SERVICE BULLETIN

APPLICABILITY: 2012MY and Later Impreza Models with FB Engine **NUMBER:** 02-141-13
 2011MY and Later Forester, N/A and Turbo Models **DATE:** 05/28/13

SUBJECT: Design Change to Rubber Sealing Cap for Oil Pressure Switch SB-10052503-5220

**Original
(old style) cap**

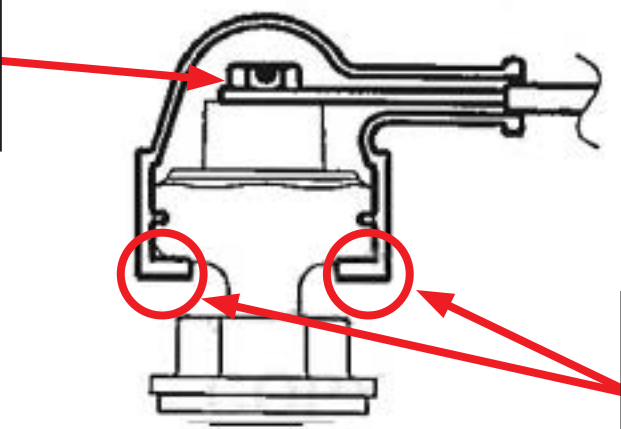
This Bulletin provides information regarding a design change to the rubber cap which covers the electrical connection at the oil pressure switch. The new cap provides better sealing and resistance to moisture intrusion which can compromise the electrical connection and in some cases, cause the oil pressure warning lamp to illuminate in error.

**4 seal breaks have
been added on the
new cap as shown.**

Be sure to follow the applicable procedure for tightening this electrical connection terminal as it varies by model.

The seal must be installed as shown with no roll-up of any of the edges.

PART NAME	NEW PART NUMBER
Cap-Terminal	22187AA080

Follow the procedure in the applicable Service Manual if replacing the oil pressure switch. Be sure to follow the proper torque procedure for both the switch **and** the electrical connection where applicable as it varies by model. The rubber material used to make the cap is soft and pliable enough so the wire and terminal eyelet can be pushed through the “tube” portion easily. Use a little bit of dielectric grease on the terminal eyelet as a lubricant if necessary. Confirm the new rubber cap is installed as shown in the illustration above with no roll-up of the bottom sealing edges.
